AMENDMENT NUMBER 1

DATE AMENDMENT ISSUED: May 29, 2015

RFP TITLE: RFP 2015-1000-3133 Western AK Aerial Survey Ground Control

Questions and Answers May 29, 2015

Figure 1. Differences between original and simplified AOI shapefiles as viewed in a subset of the planned project extent.

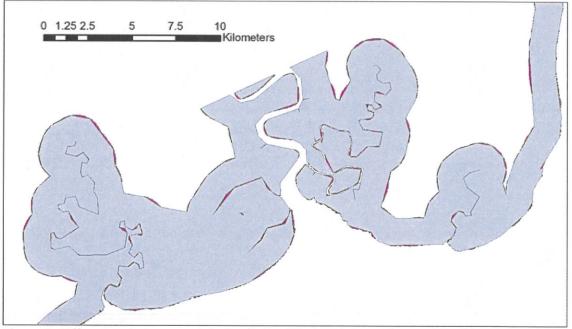
- A. CE95
- 8. Q. The provided shapefile will not load properly in some GIS tools, is there another version of the project extent shapefile?
 - A. The shapefile has been revisited in consultation with DNR GIS staff. The likely cause of the described issue is the large number of vertices that are present in the shapefile, this is a common occurrence with many coast-based features due to the fractal nature of shorelines. The shapefile that was provided with this RFP was based on the NOAA best-available MHW vector for western Alaska and the resulting polygon (a manually-edited buffer feature) has too many vertices to be displayed in some GIS or KML viewers such as Google Earth (limit of 30,000 vertices).

DNR staff have used the ArcGIS Simplify Polygon Tool using the POINT_REMOVE algorithm and a 100 m maximum allowable offset tolerance to reduce the number of vertices to approximately 10,000 so this feature may now be viewed in Google Earth. The revised shapefile is available from the Procurement Officer upon request. Differences in extent may now exist between the original and simplified shapefiles (see Figure 1 illustrating this), and the original shapefile should still be referred to for the complete area of interest. This extent discrepancy will be less of an issue for the ground control RFP than for the upcoming aerial imagery/DEM RFP."
